**ALBEMARLE COUNTY PLANNING**  
**STAFF REPORT SUMMARY**

<b>Project Name:</b> SP201800011 The Regents School of Charlottesville – Reservoir Road	<b>Staff:</b> Tim Padalino, AICP, Senior Planner
<b>Planning Commission Hearing:</b> August 20, 2019	<b>Board of Supervisors Hearing:</b> September 18, 2019
<b>Owner:</b> University of Virginia Foundation (UVAF)	<b>Applicant:</b> The Regents School of Charlottesville
<b>Acreage:</b> 19.1 acres	<b>Special Use Permit for:</b> “Private School” (Z.O. 13.2.2.5)
<b>Tax Map Parcels (TMP):</b> 07600000001700 and 075000000006600	<b>Magisterial District:</b> Samuel Miller
<b>Location:</b> Reservoir Road, approximately 900 feet west of the intersection with Fontaine Ave. Ext. and across the street from Foxhaven Farm Road <b>School Districts:</b> Murray – Elementary, Henley – Middle, and Western Albemarle – High	<b>Zoning/by-right use:</b> R-1 Residential (1 unit/acre); <b>Zoning Overlay Districts:</b> Managed Steep Slopes; Preserved Steep Slopes; Airport Impact Overlay; Entrance Corridor <b>Requested # of Dwelling Units/Lots:</b> Zero (N/A)

**SP201800011 The Regents School of Charlottesville – Reservoir Road**

Figure 7: “Western Urban Neighborhoods Parks and Green Systems Plan” (S+W Master Plan p. 25)

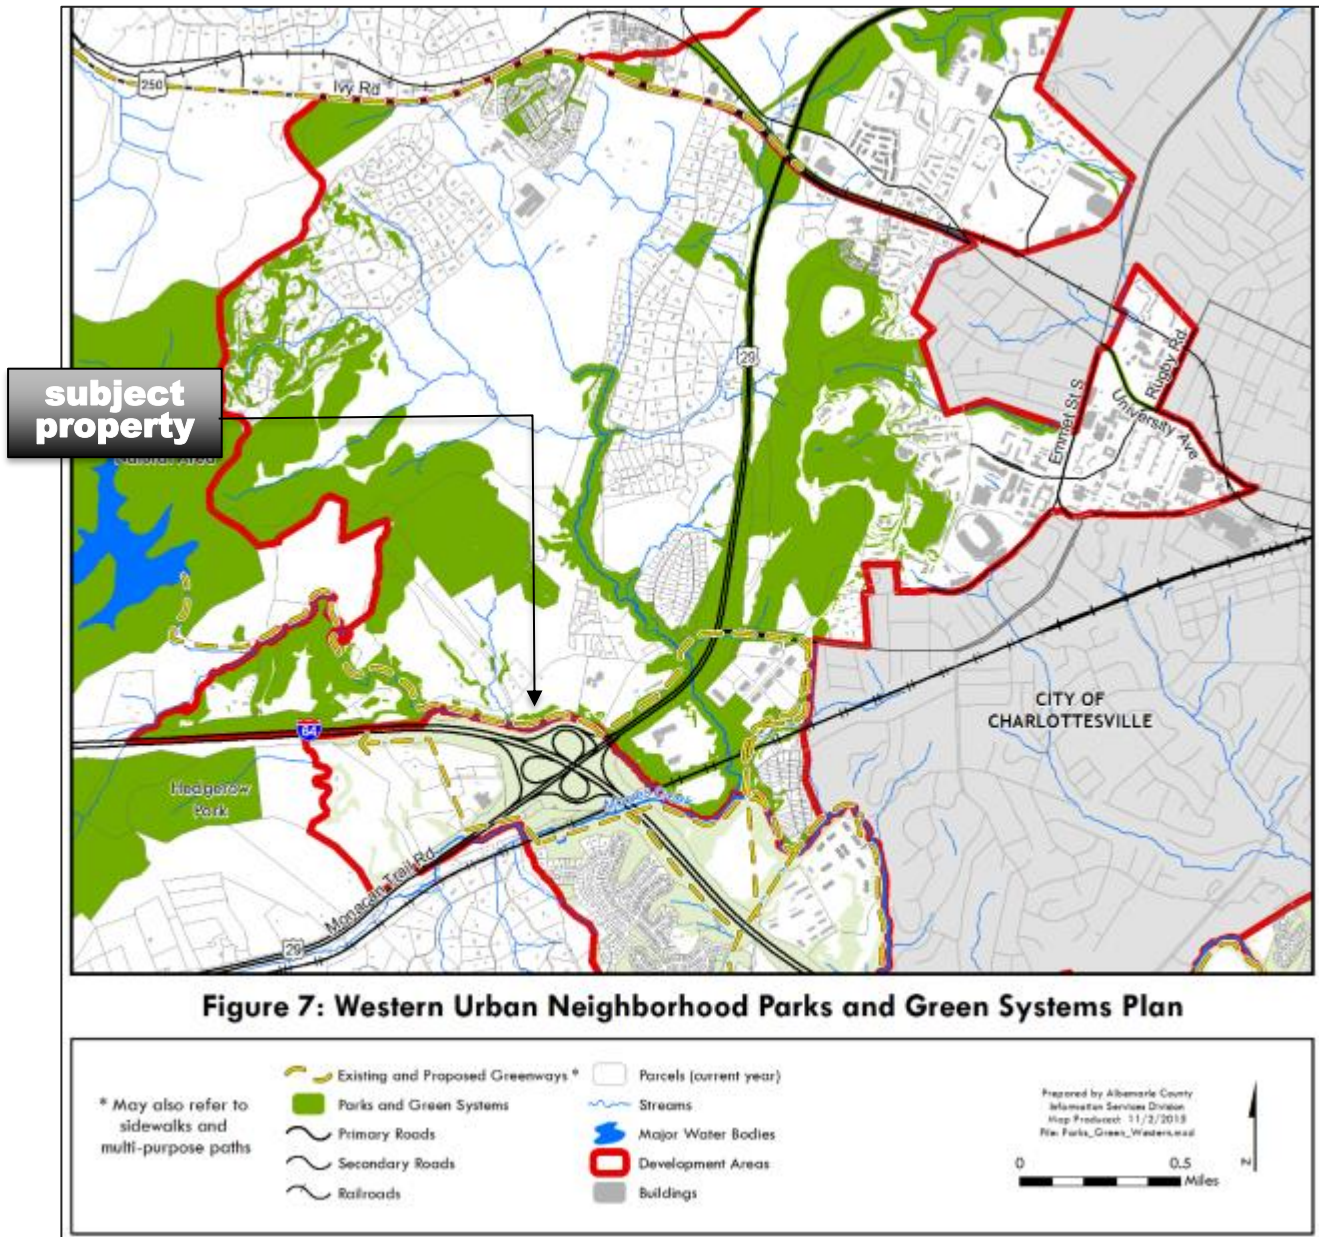
Additionally, staff have identified an element of the Parks and Green Systems Plan which is not addressed in this proposal. Specifically, that Plan shows a proposed greenway conceptually located along or near the tributary to Moore's Creek which runs along and near the southern boundary of the subject property. No such trail, multi-use path, or other greenway connection appears to be contemplated on the Concept Plan or referenced in other application materials.

Staff acknowledges that this issue had not previously been identified or discussed with the applicants; it was only identified during this most recent review (following the July 1<sup>st</sup> resubmittal). Staff also acknowledges that the subject property (TMP #75-66 and #76-17) does not have continuous frontage along this waterway, and further acknowledges that property owned by VDOT is situated between the subject property and the waterway in some locations.

Nevertheless, based on the recommendations in the S+W Master Plan (including the "Western Urban Neighborhood Parks and Green Systems Plan" and also the "Plan for Future Parks and Green Systems" and "Trail Recommendations" language identified above), and based on recent coordination between staff in the Community Development Department and the Parks and Recreation Department, staff believes this proposed greenway should be accounted for during the legislative zoning process that is required in order for the (proposed) development of the subject property to be permissible. Accordingly, staff recommends a condition of approval (#5) be established in order to address this issue.

5. The Concept Plan must be revised to make reasonable accommodation for the proposed greenway identified on the Parks and Green Systems Plan (S+W 25) and referenced in the Trails Recommendations (S+W 54), both of which are contained in the “Southern and Western Urban Neighborhoods Master Plan,” by providing a commitment to reserve lands along or near the southern boundary of the subject property (TMP #75-66 and 76-17) and along or near the tributary of Moore’s Creek for future dedication to the County for use as a greenway trail.
